ADDENDUM NO. 3

Project: Beatrice Middle School Renovations

Project No.: L13017

Date: 5/17/2013

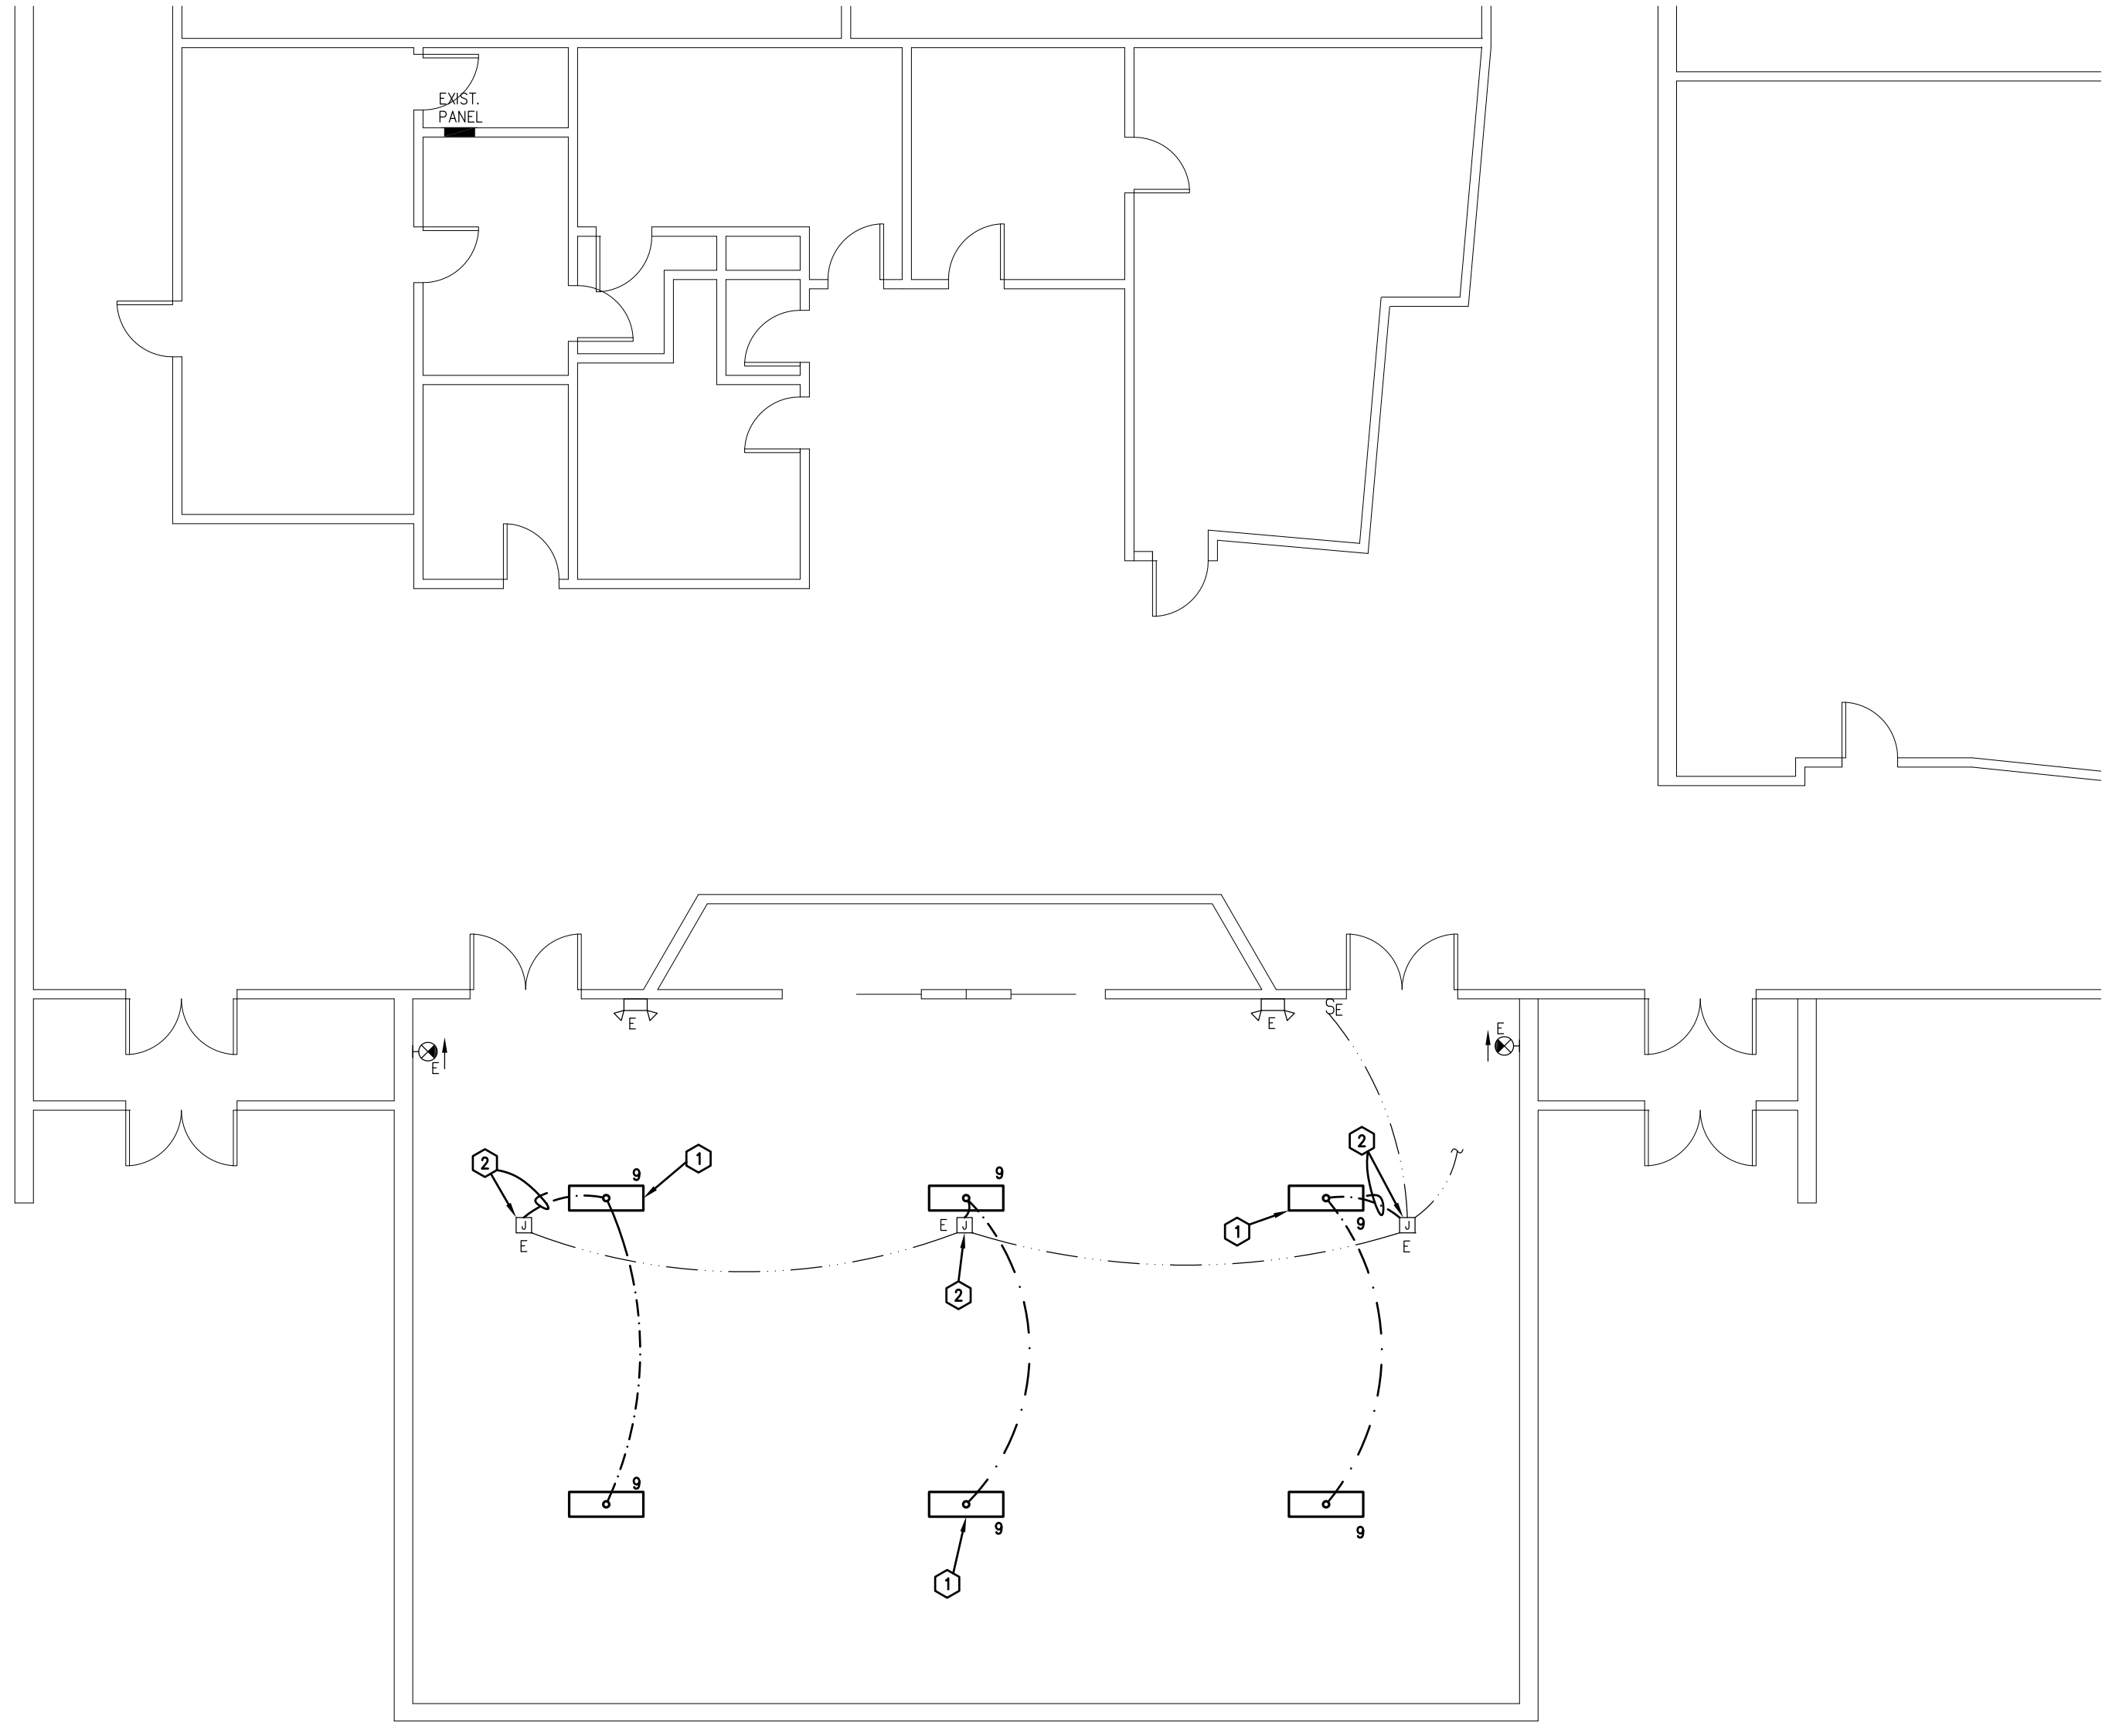
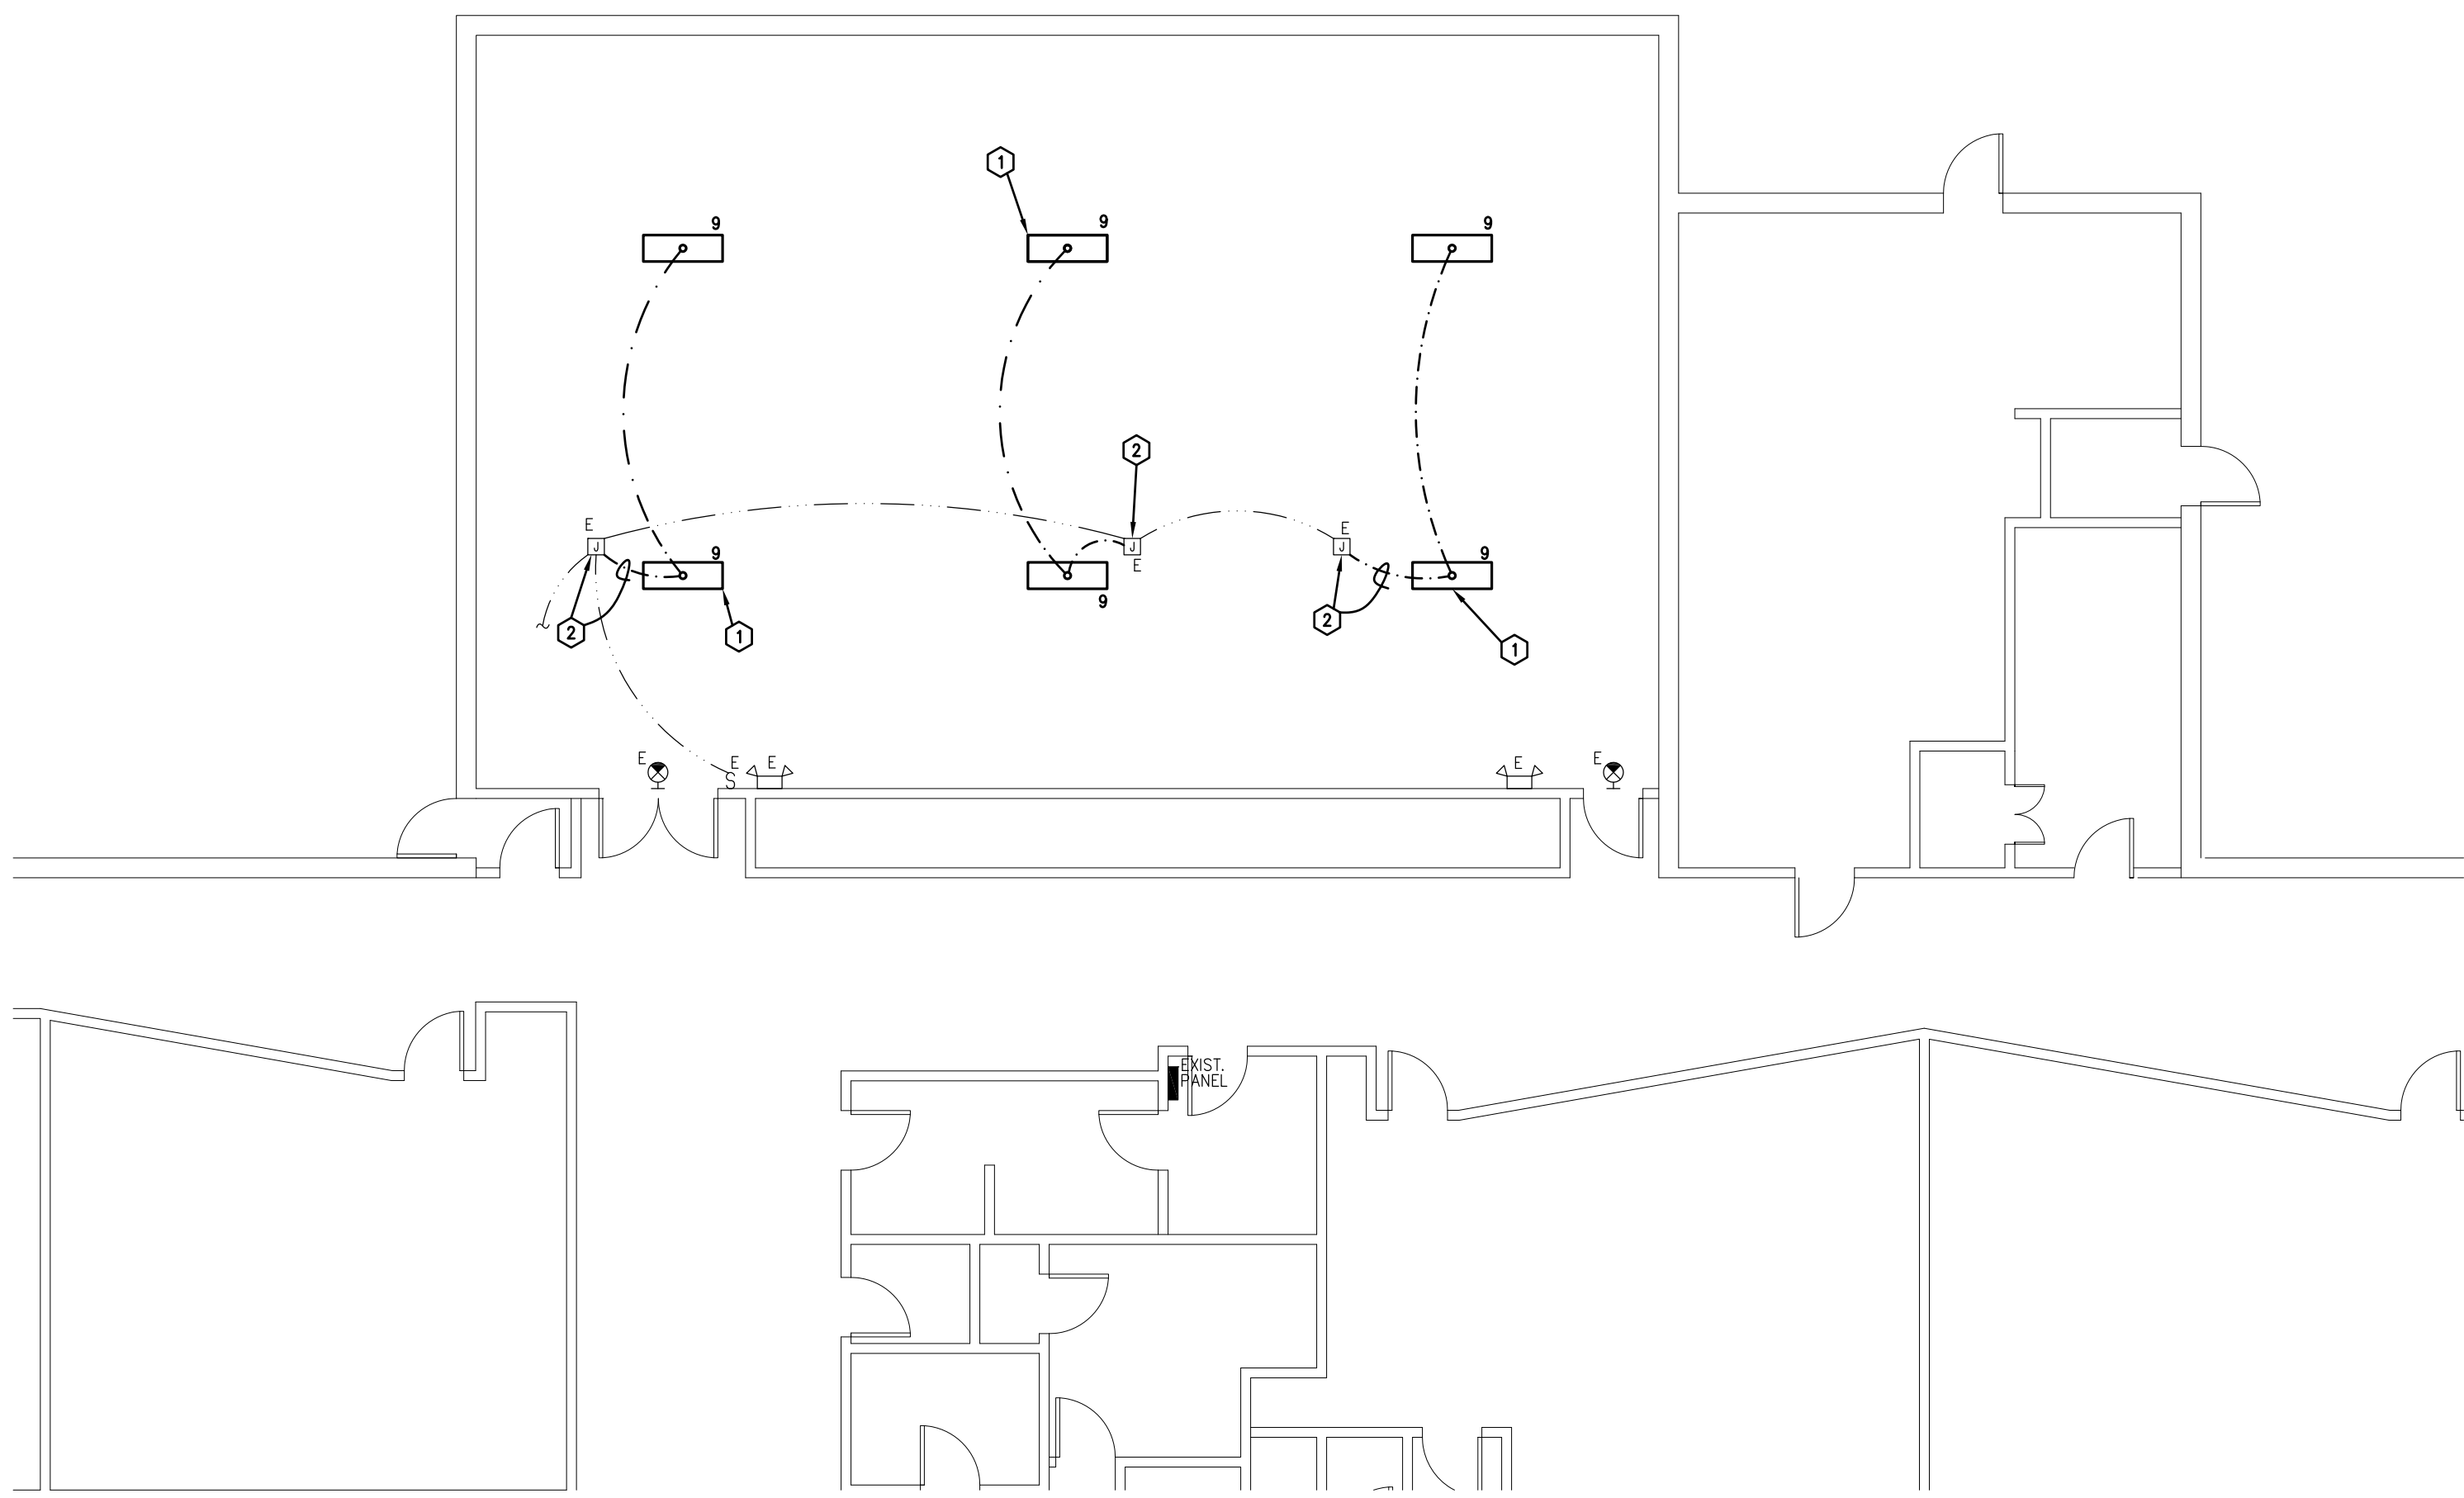
1. See attached drawing E1.3 indicating the removal and replacement of lighting at the Multi-Purpose Rooms at Paddock Lane, Stoddard, Lincoln and Cedar Elementary Schools.
 - A. This work shall be bid as Alternate No. 1.

- 1 SHEET NOTES**
- REMOVE AND REPLACE EXISTING LIGHT FIXTURE WITH NEW LIGHT FIXTURE SHOWN.
 - EXISTING JUNCTION BOX AND LIGHTING CIRCUIT TO REMAIN. EXTEND LIGHTING CIRCUIT TO NEW LIGHT FIXTURES AS REQUIRED.
